SERVICE BULLETIN
SUMMARY

ATA SYSTEM: 21

**TITLE: AIR CONDITIONING - CARGO COMPARTMENT HEATING - CHANGE
POSITION OF PRESSURE REGULATION VALVE**

MODIFICATION No.: 150447K12993

Figure A-GBAAA - Sheet 01

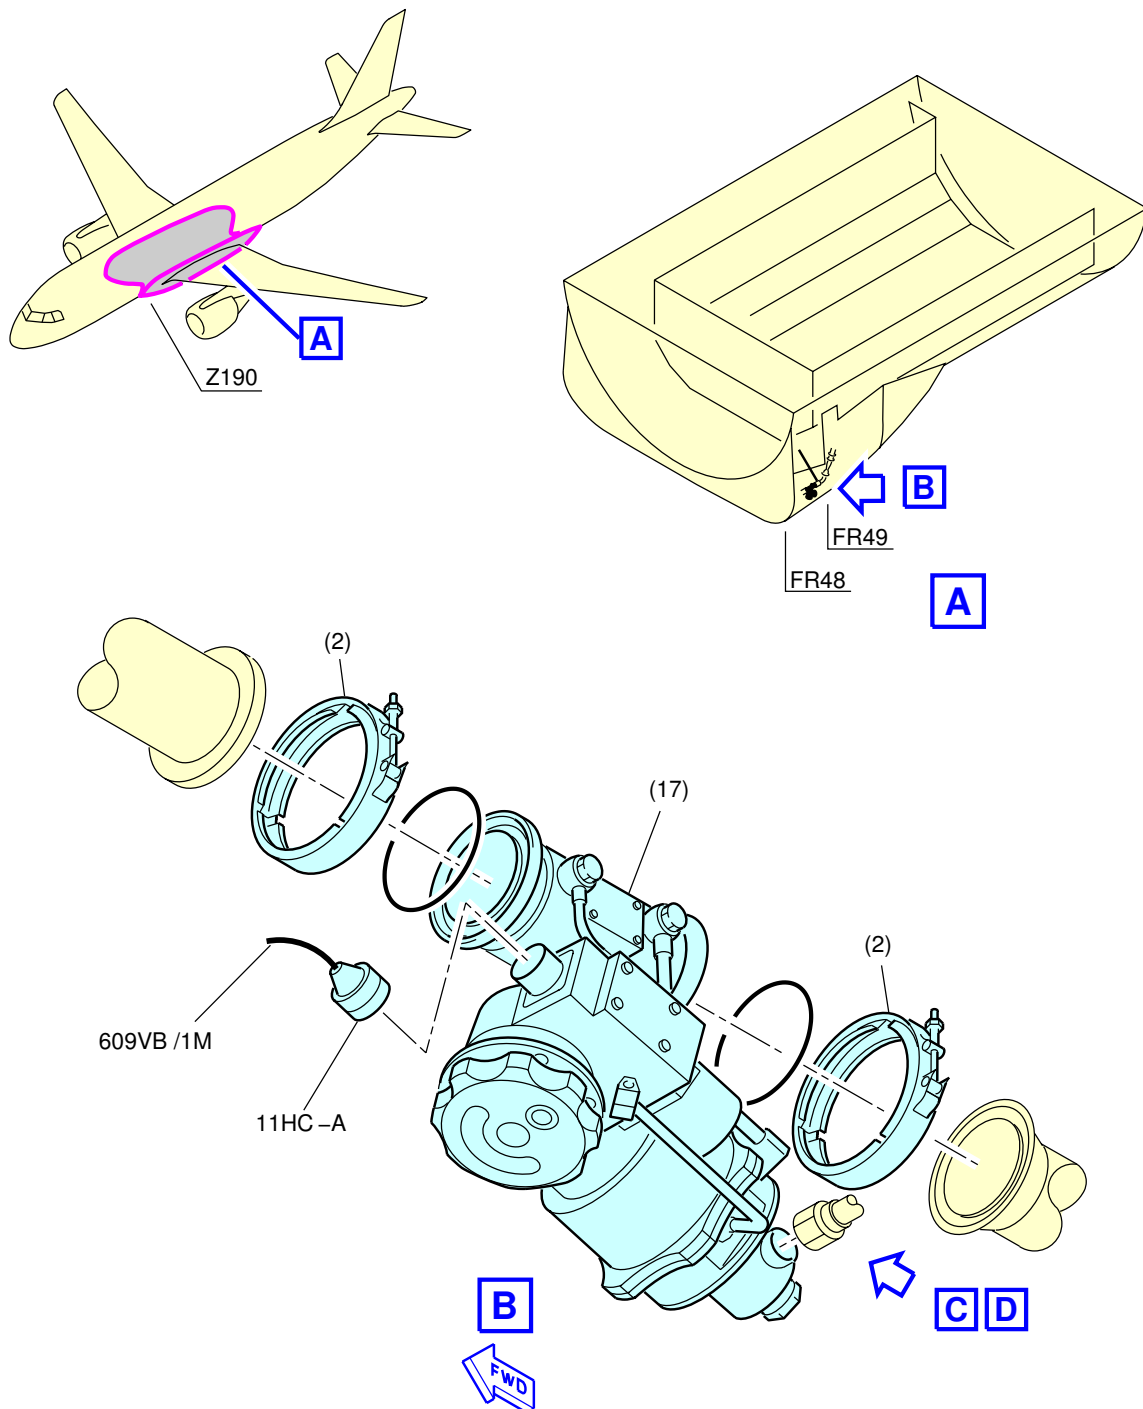
5 Rotate the Cargo Heat Pressure Regulating Valve, FIN 11HC, Item (17), by 107 degree to the modified installation location.

Figure A-GBAAA - Sheet 04

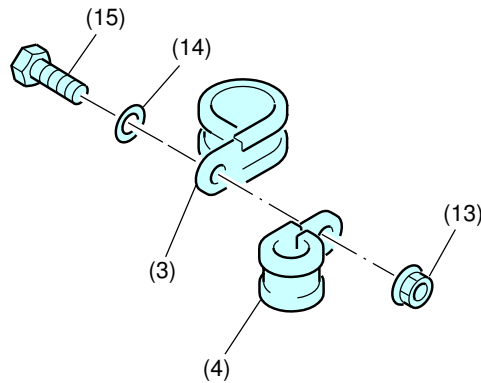
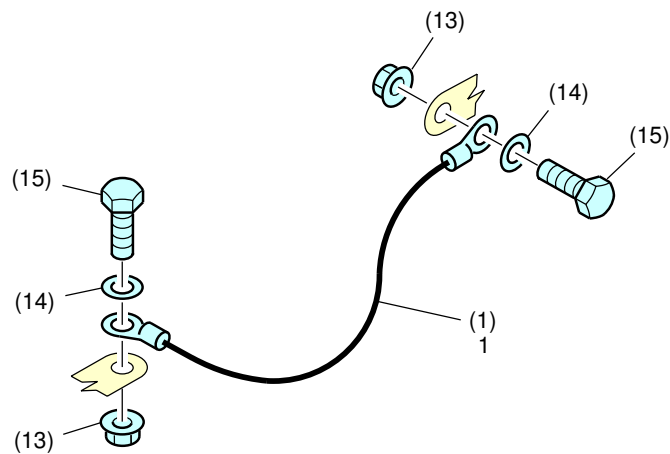
- 7 Adapt the sense line hose clamps to accommodate the revised routing, connect the sense line hose and secure the routing clamps (Refer to AMM Task 21-43-52-400-001).

Figure A-GBAAB - Sheet 01
Modification of the Installed Position for the Cargo Heat Pressure Regulating Valve, FIN 11HC, between FR47.1 and FR47.2, LH.

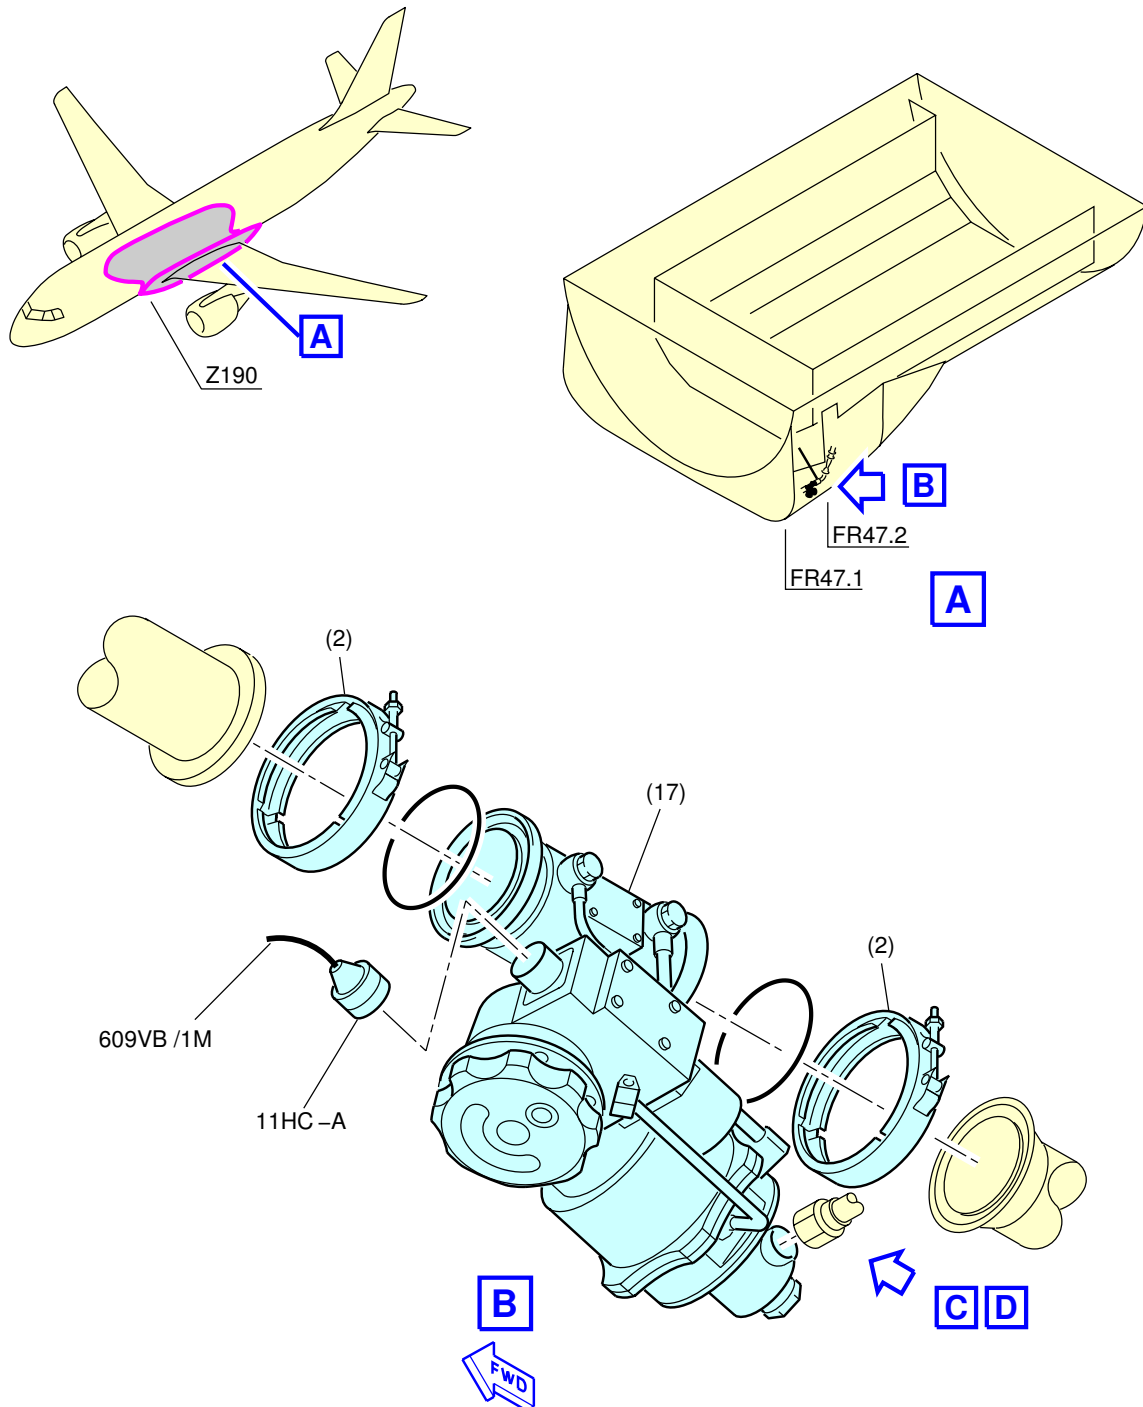
5 Rotate the Cargo Heat Pressure Regulating Valve, FIN 11HC, Item (17), by 107 degree to the modified installation location.

Figure A-GBAAB - Sheet 04

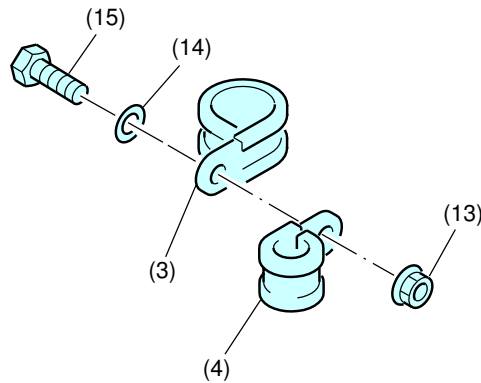
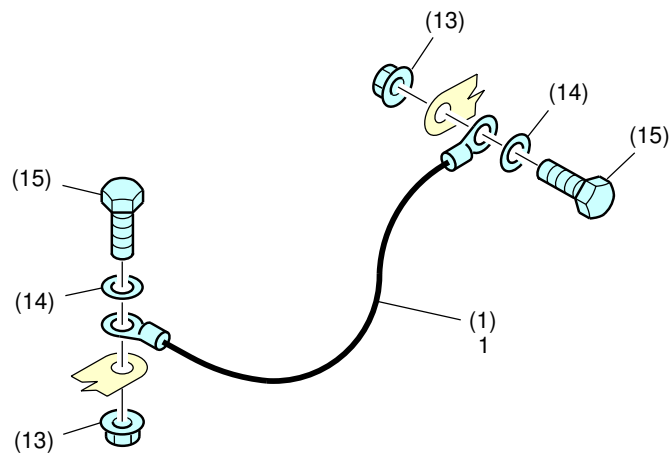
- 7 Adapt the sense line hose clamps to accommodate the revised routing, connect the sense line hose and secure the routing clamps (Refer to AMM Task 21-43-52-400-001).

Figure A-GBAAC - Sheet 01

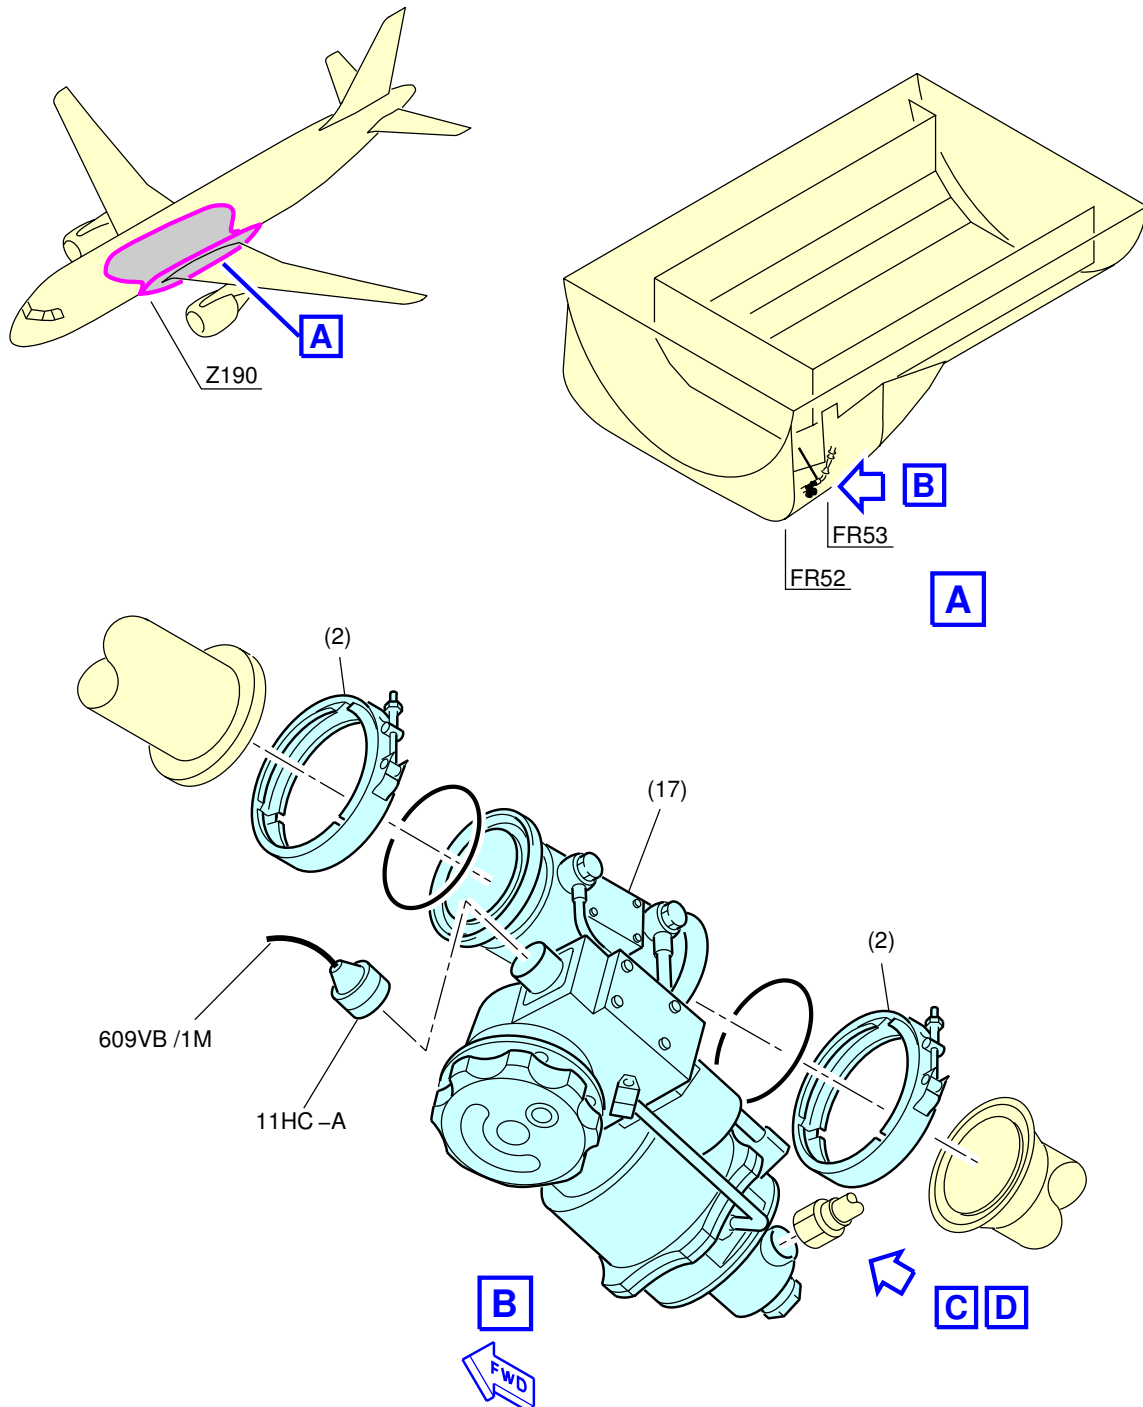
5 Rotate the Cargo Heat Pressure Regulating Valve, FIN 11HC, Item (17), by 107 degree to the modified installation location.

Figure A-GBAAC - Sheet 04

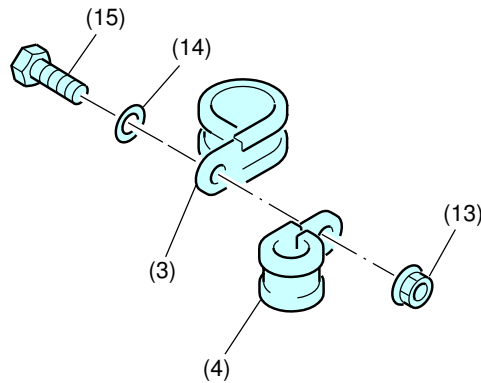
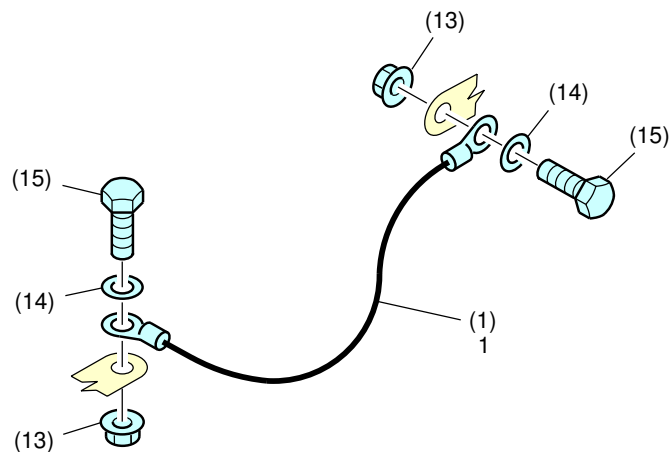
- 7 Adapt the sense line hose clamps to accommodate the revised routing, connect the sense line hose and secure the routing clamps (Refer to AMM Task 21-43-52-400-001).

Figure A-GBAAD - Sheet 01

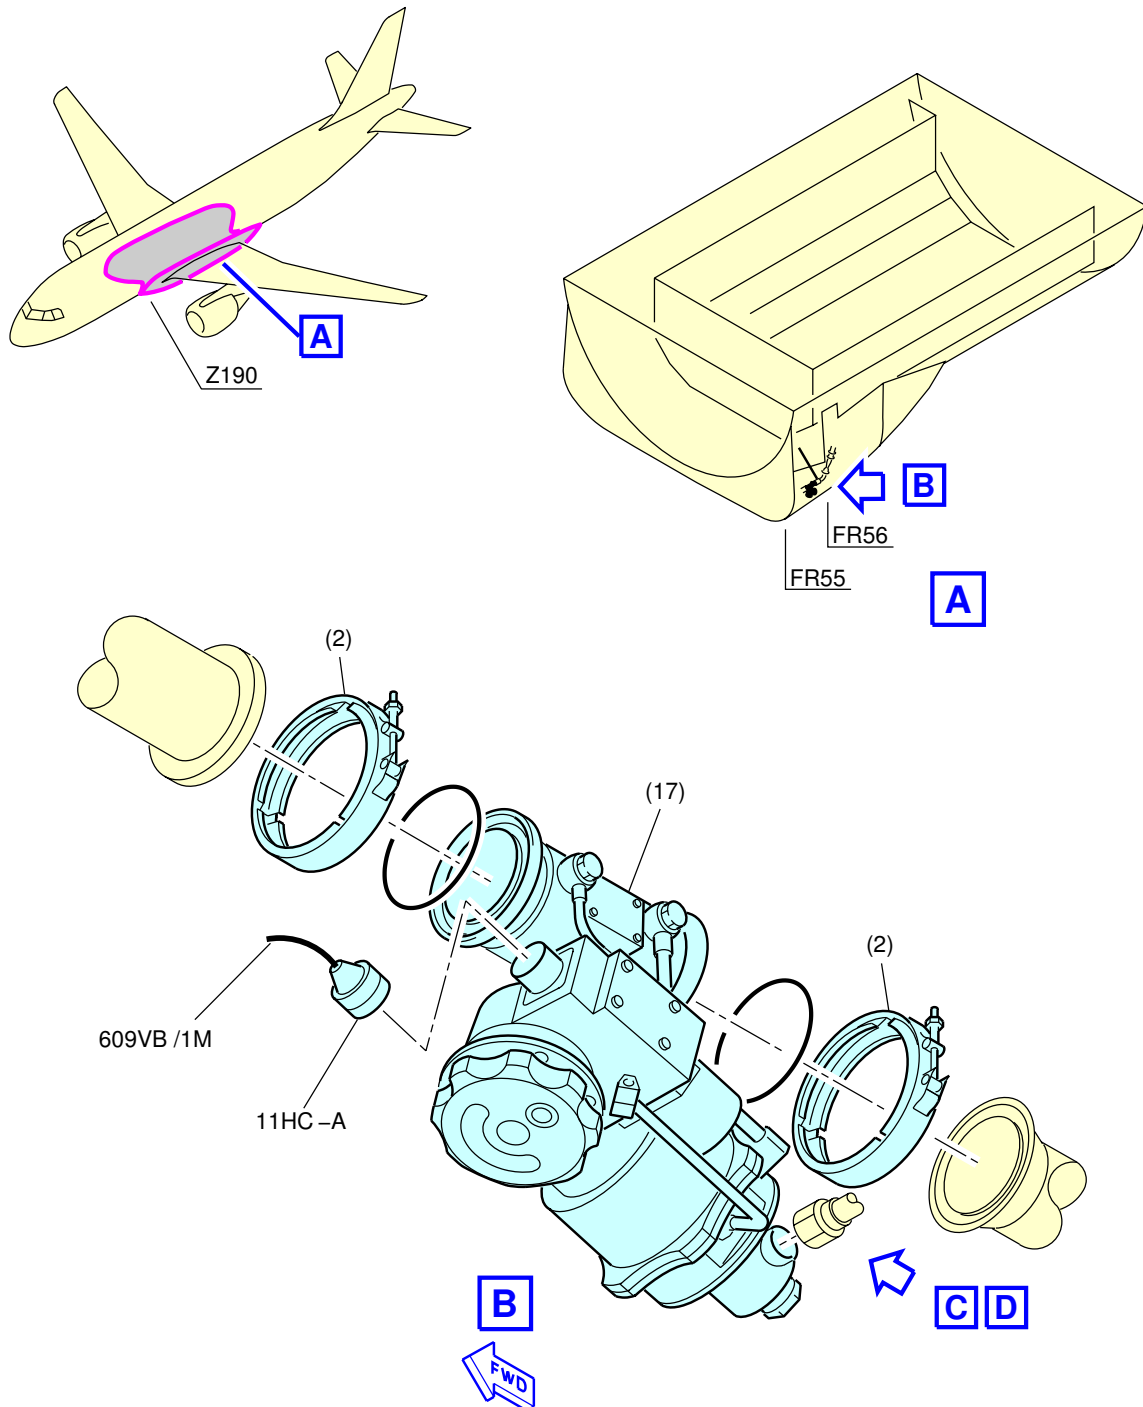
5 Rotate the Cargo Heat Pressure Regulating Valve, FIN 11HC, Item (17), by 107 degree to the modified installation location.

Figure A-GBAAD - Sheet 04

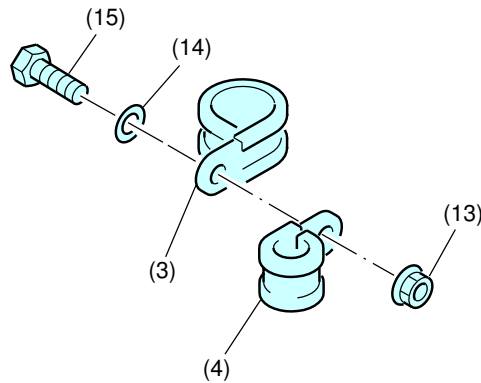
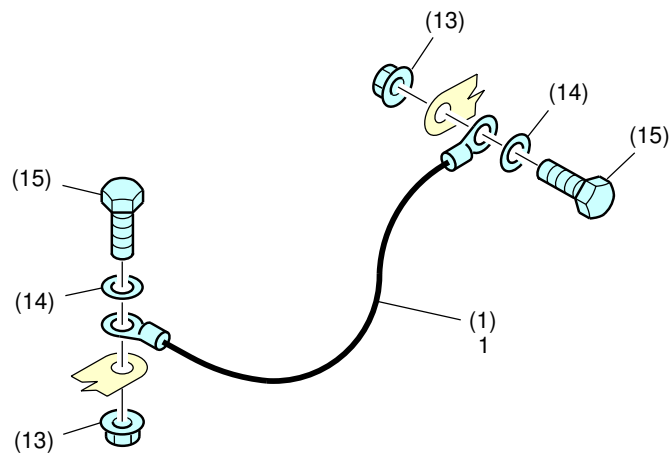
- 7 Adapt the sense line hose clamps to accommodate the revised routing, connect the sense line hose and secure the routing clamps (Refer to AMM Task 21-43-52-400-001).

Figure A-GBBAA - Sheet 01
Modification of the Routing for Wire Harness , 609VB/1M, at the Cargo Heat Pressure Regulating Valve, FIN 11HC, between FR48 and FR49, LH.

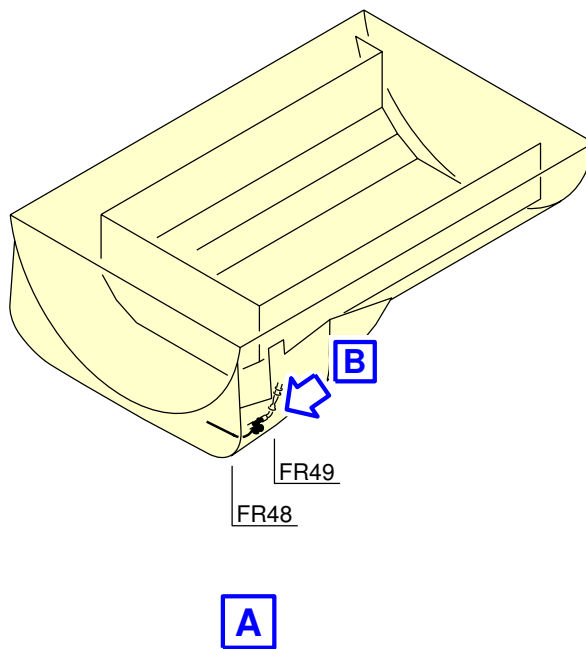
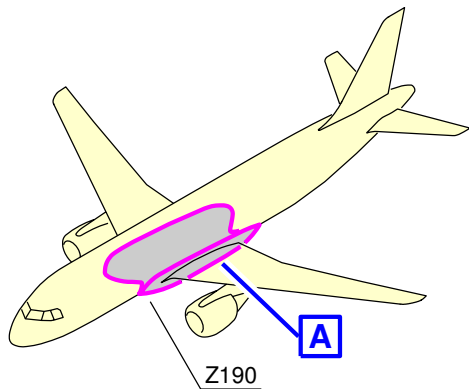
(2) Modify the routing for wire harness, 609VB/1M, at the Cargo Heat Pressure Regulating Valve, FIN 11HC, located between FR48 and FR49, LH.

Figure A-GBBAB - Sheet 01

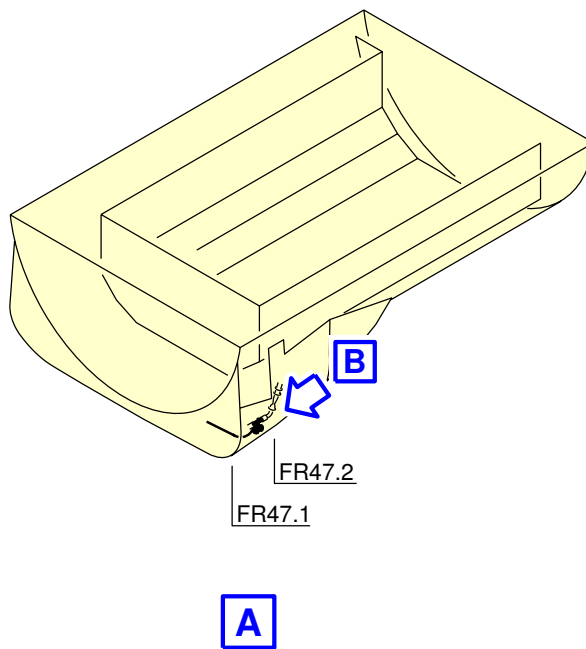
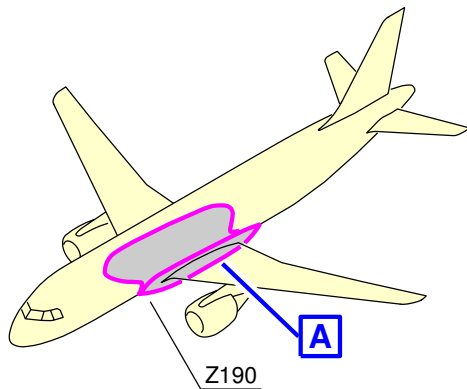
- (1) Modify the installed position of the Cargo Heat Pressure Regulating Valve, FIN 11HC, located between FR47.1 and FR47.2, LH.
- (2) Modify the routing for wire harness, 609VB/1M, at the Cargo Heat Pressure Regulating Valve, FIN 11HC, located between FR47.1 and FR47.2, LH.

Figure A-GBBAC - Sheet 01
Modification of the Routing for Wire Harness , 609VB/1M, at the Cargo Heat Pressure Regulating Valve, FIN 11HC, between FR52 and FR53, LH.

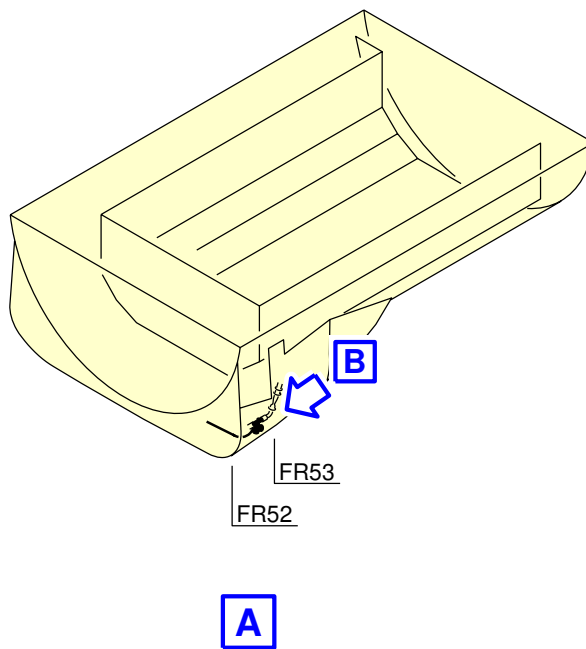
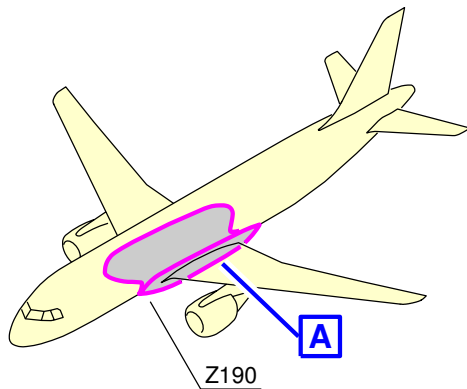
- (1) Modify the installed position of the Cargo Heat Pressure Regulating Valve, FIN 11HC, located between FR52 and FR53, LH.
- (2) Modify the routing for wire harness, 609VB/1M, at the Cargo Heat Pressure Regulating Valve, FIN 11HC, located between FR52 and FR53, LH.

Figure A-GBBAD - Sheet 01
Modification of the Routing for Wire Harness , 609VB/1M, at the Cargo Heat Pressure Regulating Valve, FIN 11HC, between FR55 and FR56, LH.

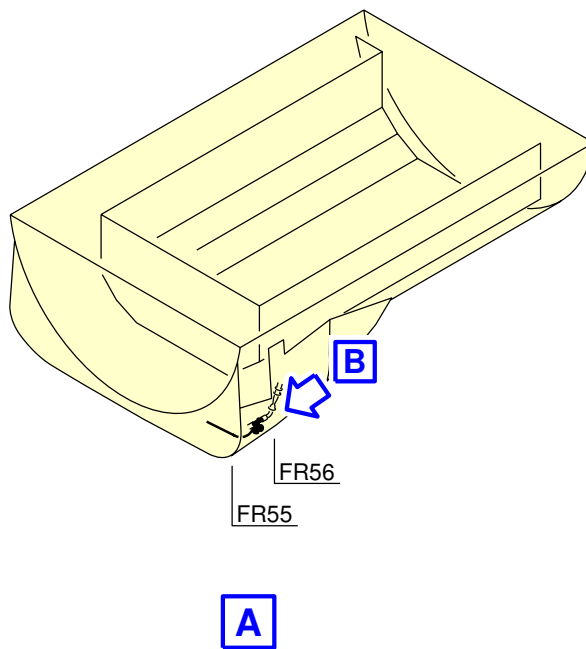
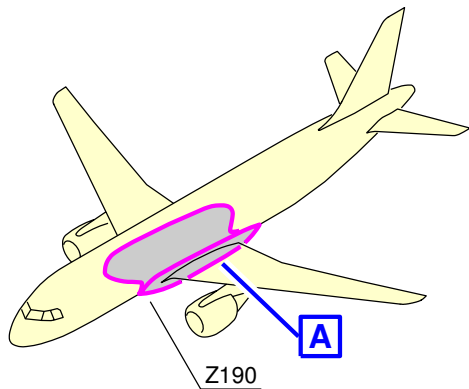
- (1) Modify the installed position of the Cargo Heat Pressure Regulating Valve, FIN 11HC, located between FR55 and FR56, LH.
- (2) Modify the routing for wire harness, 609VB/1M, at the Cargo Heat Pressure Regulating Valve, FIN 11HC, located between FR55 and FR56, LH.
